Crystal River Nuclear Plant
Docket No. 50-302
Operating License No. DPR-72

Subject: Crystal River Unit 3 – Core Operating Limits Report, Cycle 14, Revision 3

**Core Operating Limits Report (COLR)
Cycle 14, Revision 3**

Cycle 14 Core Operating Limits Report

Regulating Rod Insertion Limits

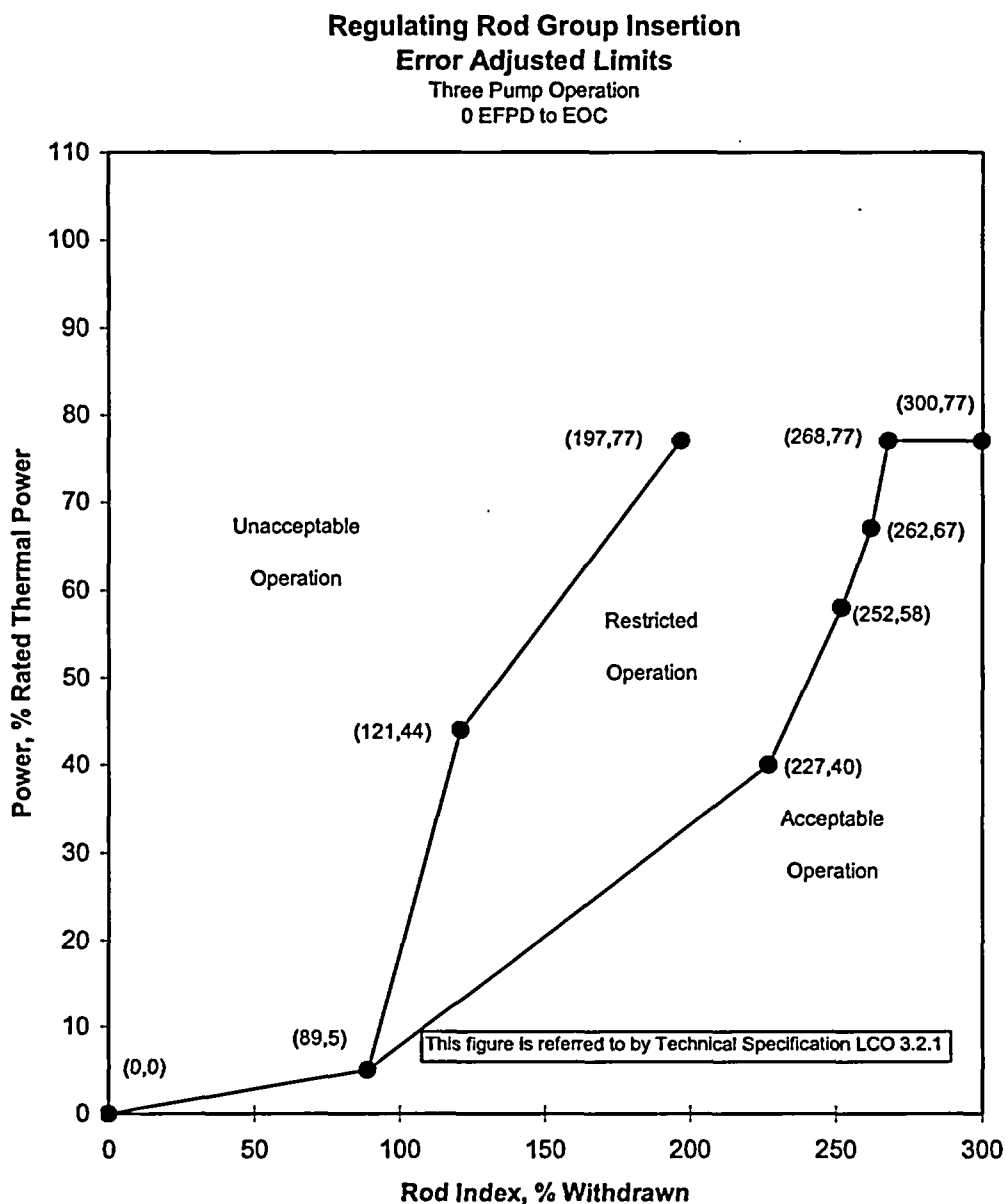
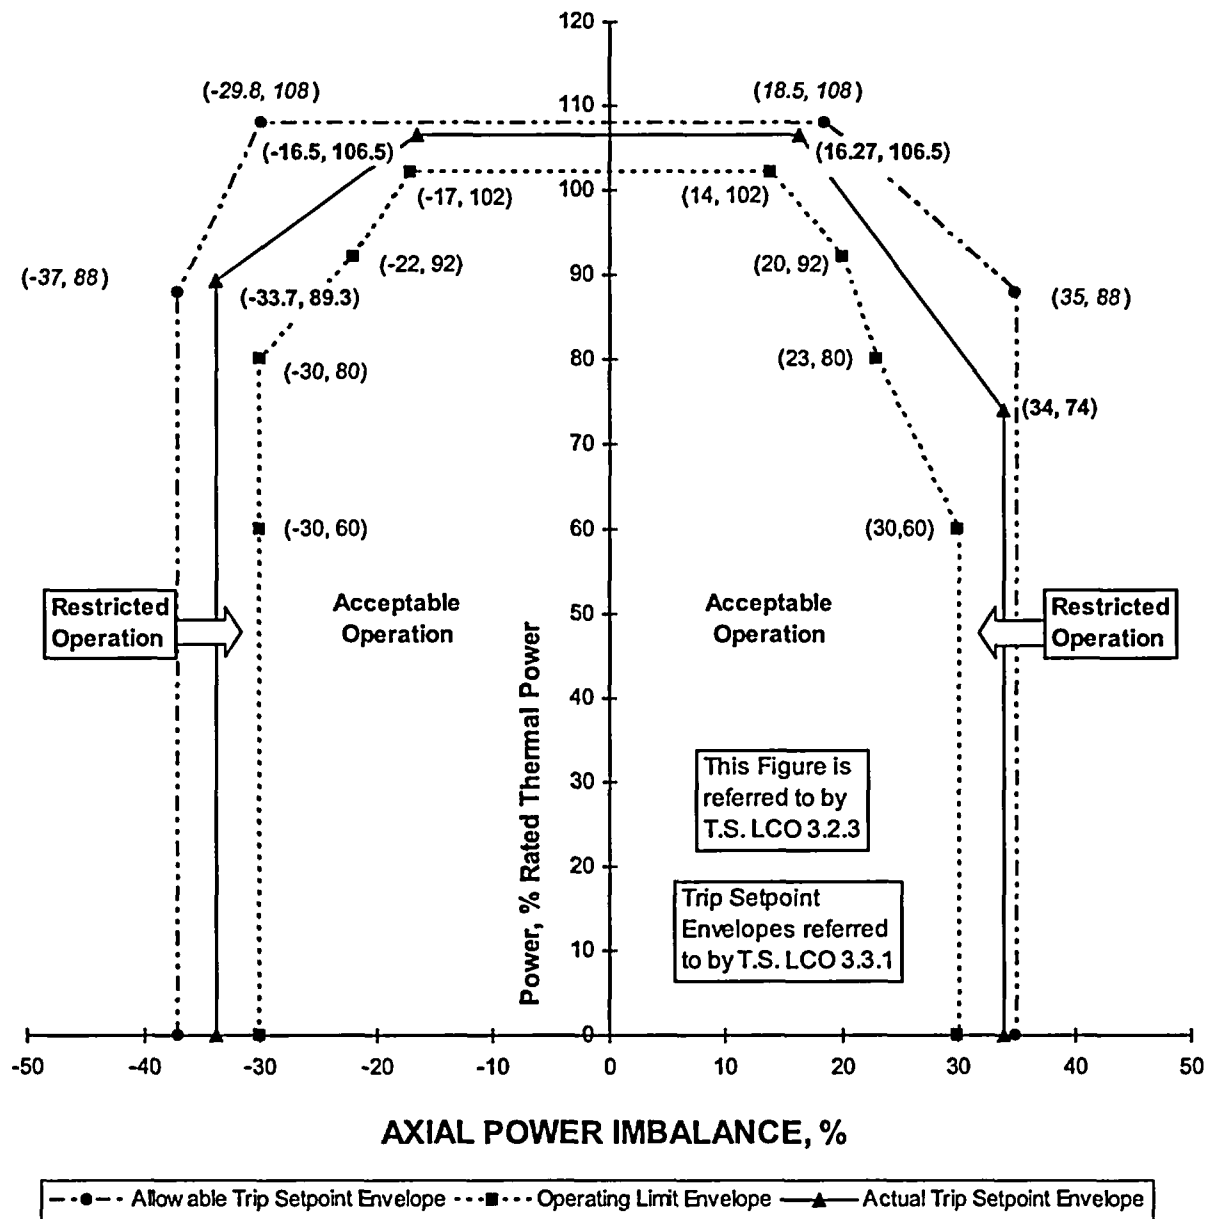
COLR revised to remove Note regarding APSR withdrawal from Regulating Rod Insertion Limits curves, as found on pages 7 and 8 of 22. The Axial Power Shaping Rod (APSR) Insertion Limits (page 9 of 22) was rewritten to remove the requirement to withdraw the APSRs. These changes are shown acceptable in Reference 12. Additionally a refueling boron concentration was added to support Cycle 14 Mode 6 shutdown and offload conditions to page 21 of 22.
